V.C. Summer Site Response Analysis

NRC Meeting

April 1, 2009

2.5.4.7.2 Vs – Measured (Suspension P-S Logging)

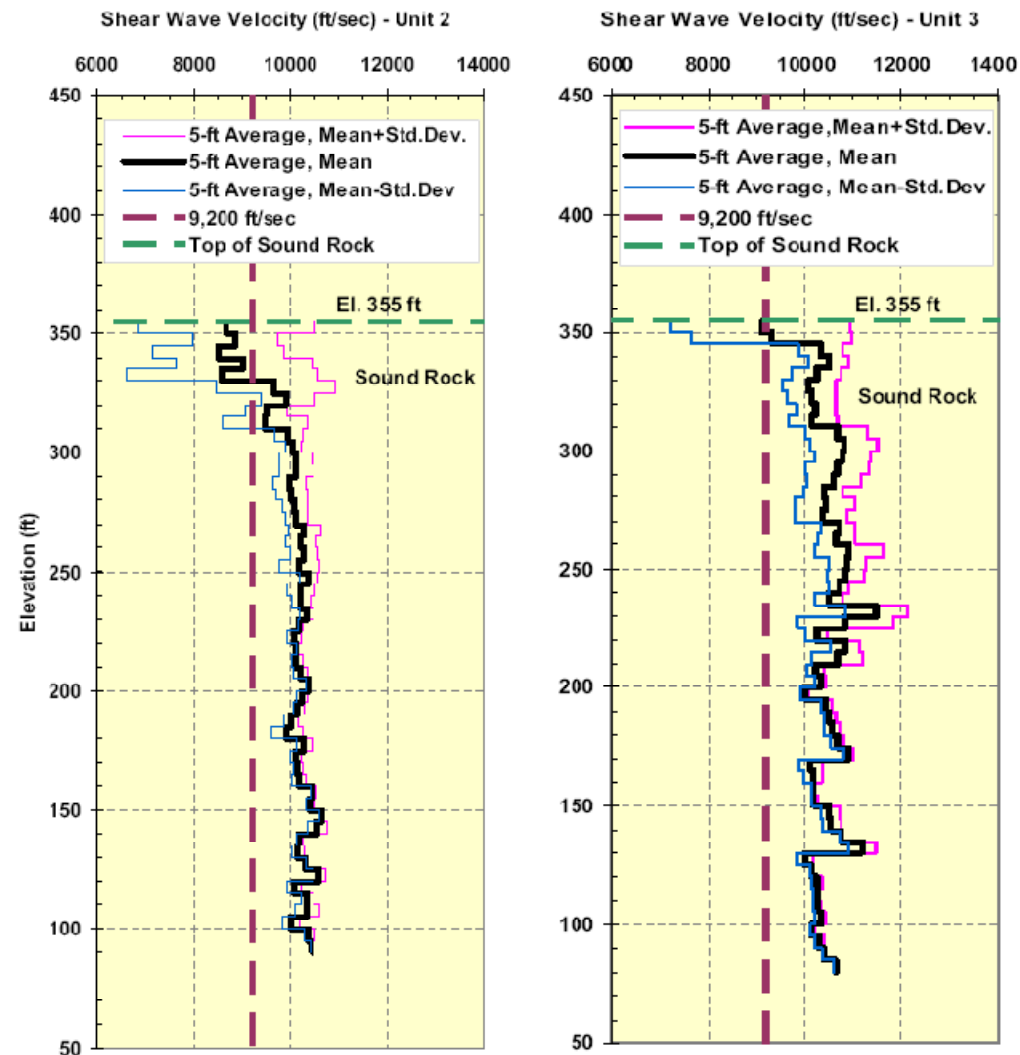
FSAR Section 2.5.2.5 states that the site is underlain by weathered and unweathered bedrock with a high shear velocity (greater than 8,500 fps) and, therefore, a site response analysis was not performed to develop the GMRS because the S-wave velocity is consistent (i.e. within the uncertainty) with the ground motion model used in the PSHA (S-wave velocity greater than 9,200 fps). While FSAR Figure 2.5.4-226, "Shear Wave Velocity of Layer V with 5-Foot Vertical Distance Averaging" shows the mean S-wave velocity to be greater than 8,500 fps, the profile exhibits a large standard deviation particularly below Unit 2 in the 310 to 355 ft elevation range. FSAR Section 2.5.4.7.3 presents the results of site response calculations but does not discuss the impact of the site response on the GMRS.

Please provide additional justification for not performing a site response calculation as part of the development of the GMRS, in light of the significant S-wave velocity variability beneath the site and the observed S-wave velocity values that are significantly less than 8,500 fps.
